February 18, 2025

Walton County, GA  
The Grove, a Walton County Parks &  
Recreation Facility

### Change Proposal #29 – Sewer MH-M1 PVC to DIP Material Change

C5.27

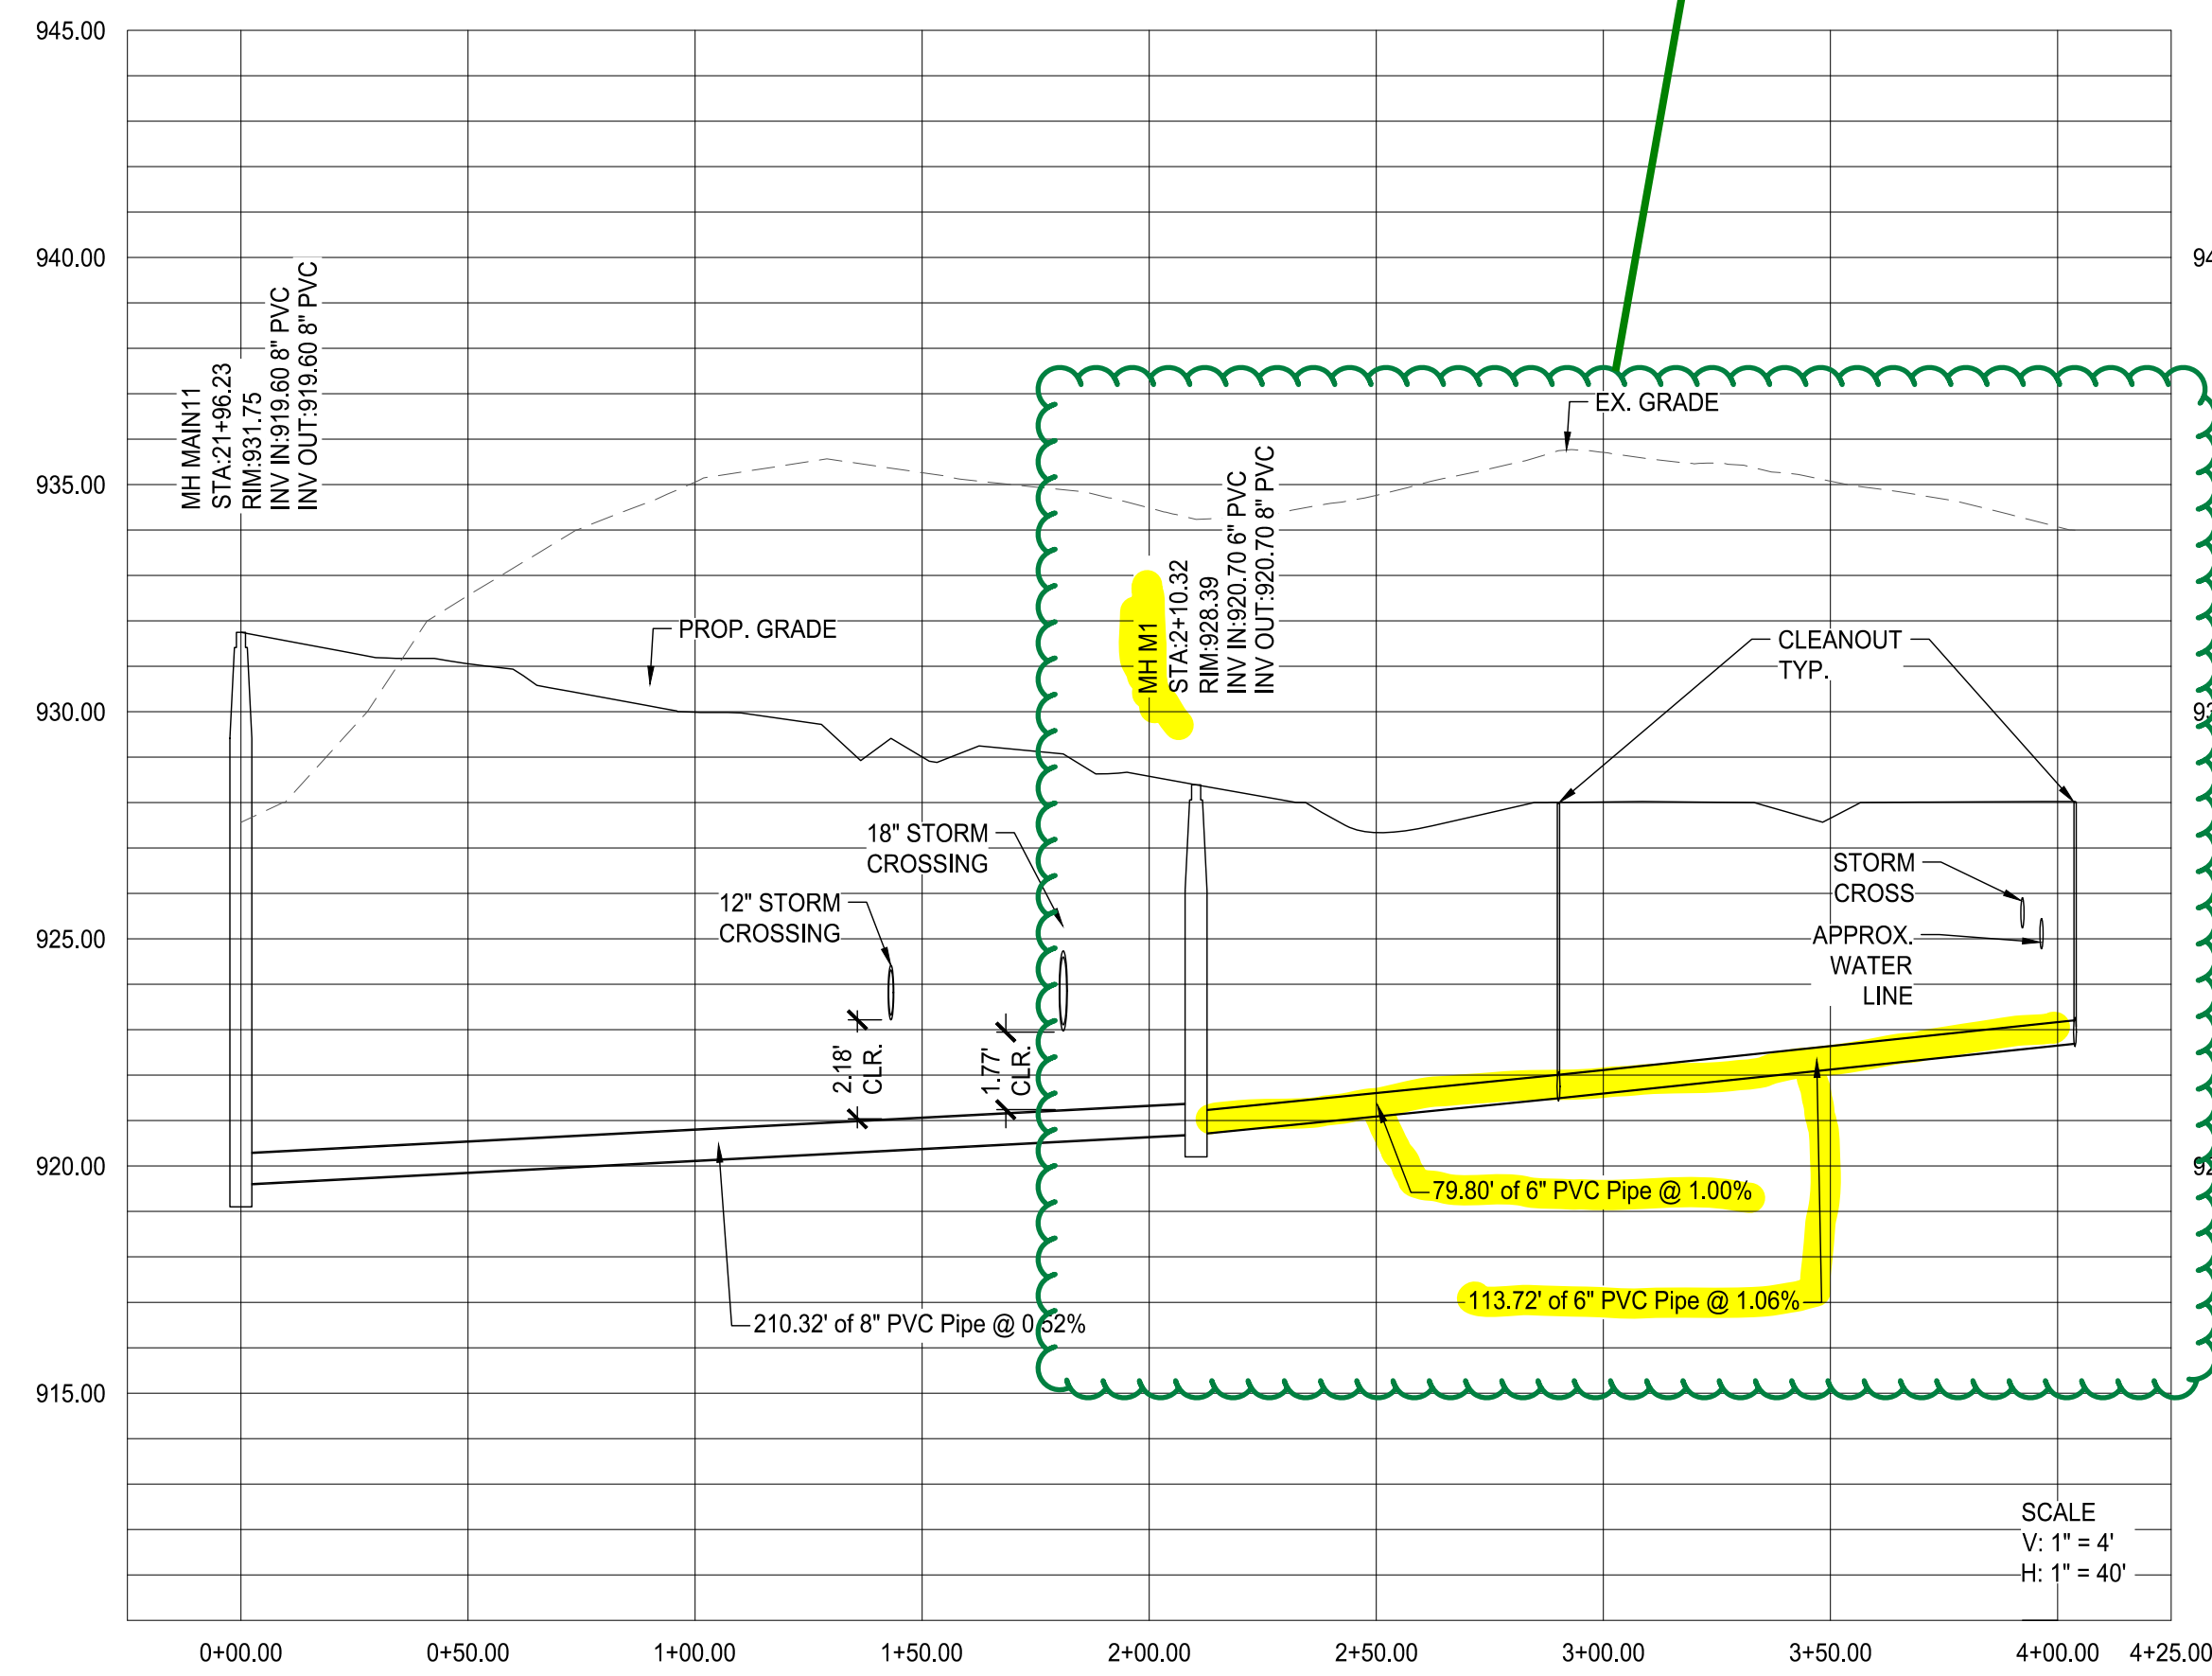
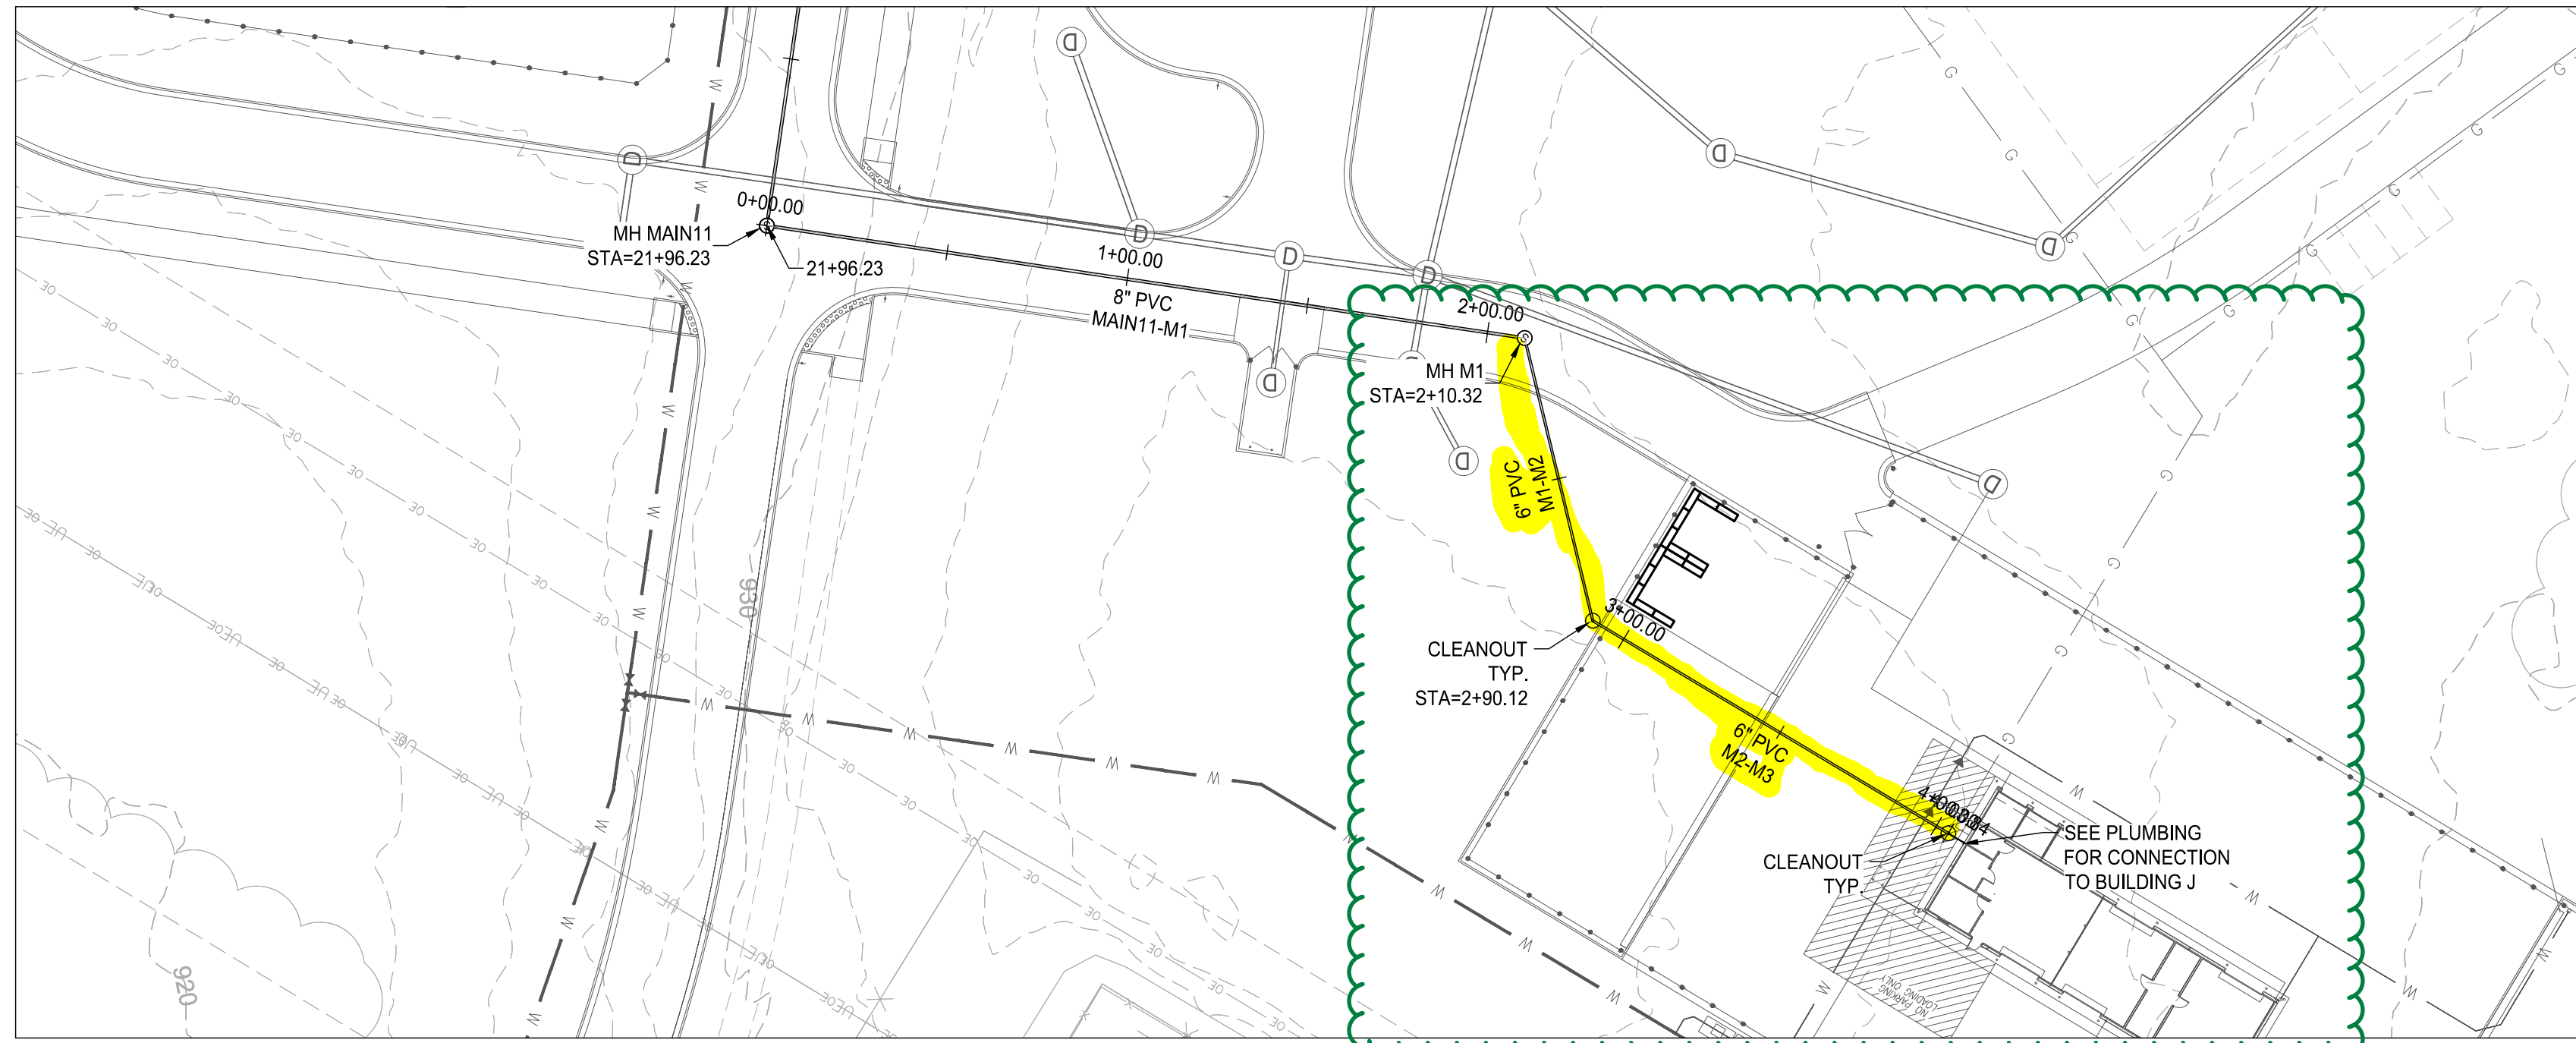
The change proposal below is for material change of roughly 200 LF of 6” PVC pipe to 200 LF of 6” Ductile Iron pipe at Building J’s sewer line. In the original Civil drawing bid set “Addendum #3” dated 04.21.23, Sheet C5.27 shows the sewer profile for Building J originally included 200 LF of 6” PVC pipe at MH-M1. This was later revised to 6” Ductile Iron pipe in the “Corrected Conformed Civil Set” dated 08.08.24. While these revisions were incorporated into the latest drawing updates, they were not clouded or explicitly noted. Supporting documentation is provided below. Additionally, included in the change proposal is the credit of the 200 LF of 6” PVC pipe.
